CRIDEN ESTATES SUBDIVISION,
SECOND RESUBDIVISION OF,
RESUBDIVISION OF LOT 6, BLOCK "A"

APPLICATION NUMBER 13 DATE May 4, 2006

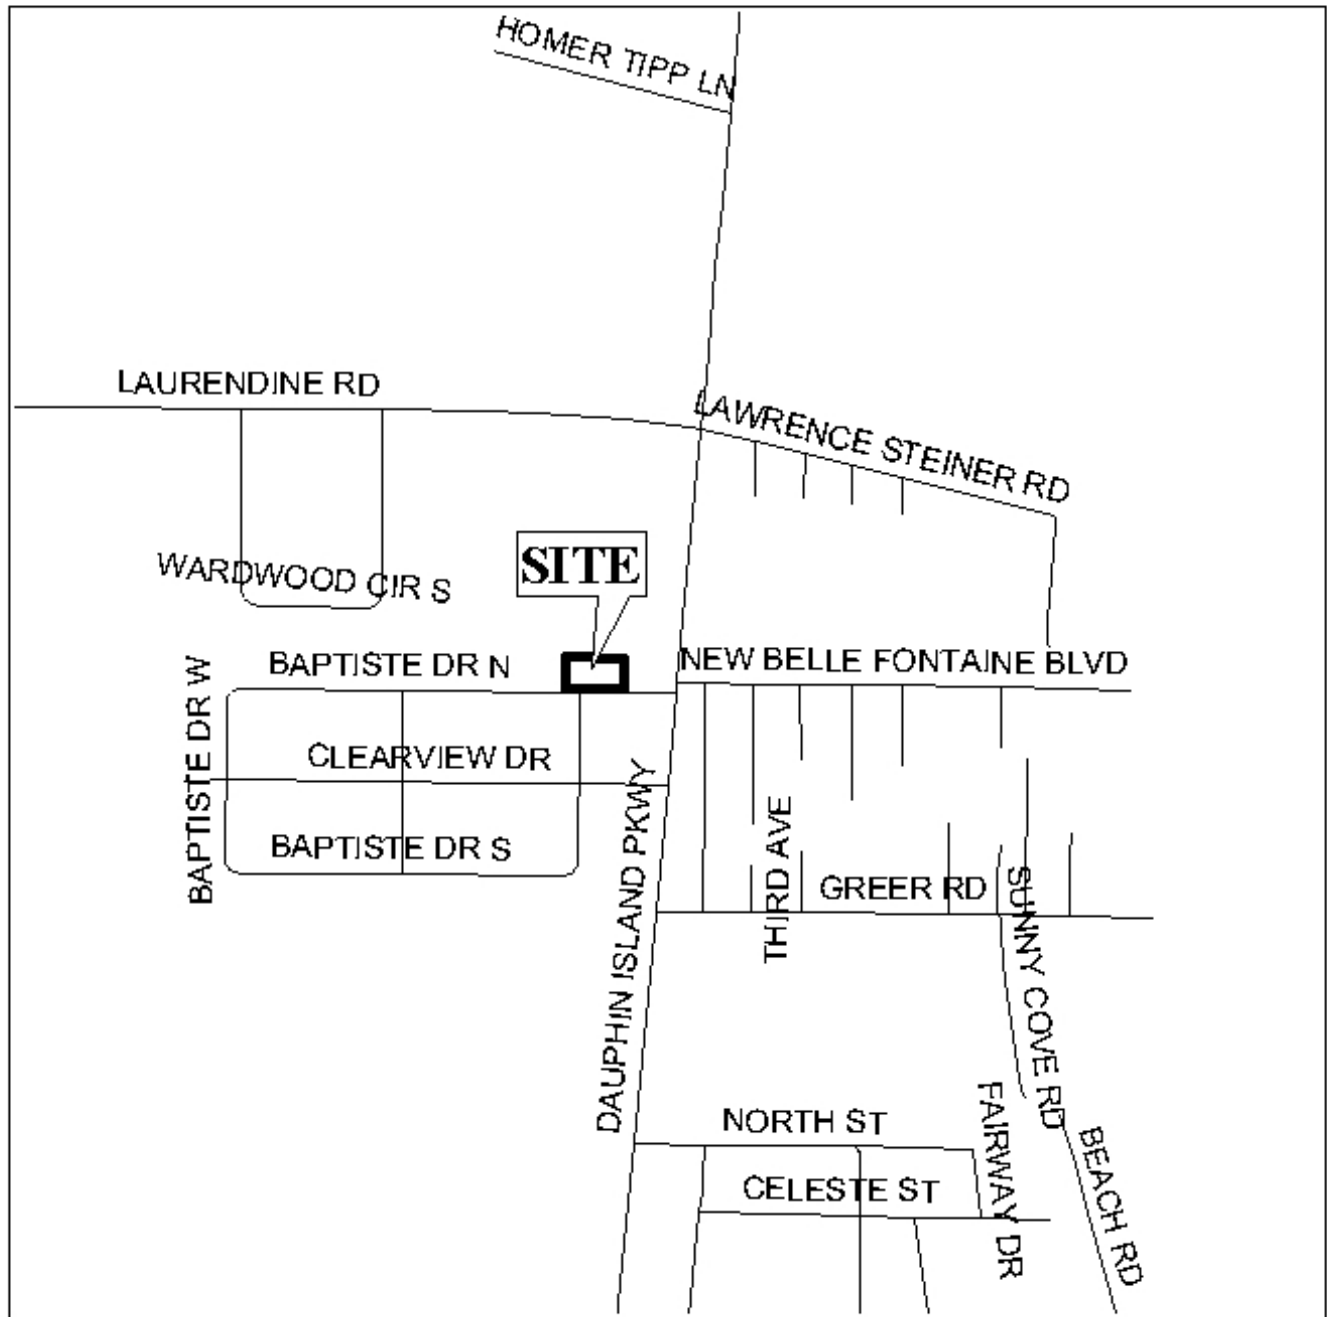
The plat illustrates the proposed two-lot, 1.1± acre subdivision, which is located at 3135 and 3137 Baptiste Drive North (on the North side of Baptiste Drive North, 240'± West of Dauphin Island Parkway). The site is served by public water and individual septic systems.

The purpose of the application is to redraw the lot line between two existing, developed lots of record.

The site fronts Baptiste Drive North, which has a 60-foot right-of-way. As a means of access management, the site should be limited to a single curb cut for each lot.

The site would continue to provide 14,323 square feet per lot, which is less than the 15,000 square foot minimum required by City Subdivision Regulations and the Alabama Department of Public Health for sites served by public water and individual septic systems. However, since the site is already developed and density would not increase, it seems acceptable to waive Section V.D.2 (minimum dimensions) of the Subdivision Regulations. Regarding the State regulations, it will be the applicant's responsibility to consult with the appropriate officials regarding the site.

With a waiver of Section V.D.2 (minimum dimensions), the plat will meet the minimum requirements of the Subdivision Regulations and is recommended for Tentative Approval, subject to the following conditions: 1) the placement of a note on the final plat stating that the site is limited to a single curb cut; 2) that the applicant obtain all relevant permits from the Alabama Department of Public Health prior to the issuance of any permits; and 2) the placement of a note on the final plat stating that any lots that are developed commercially and adjoin residentially developed property must provide a buffer, in compliance with Section V.A.7 of the Subdivision Regulations.
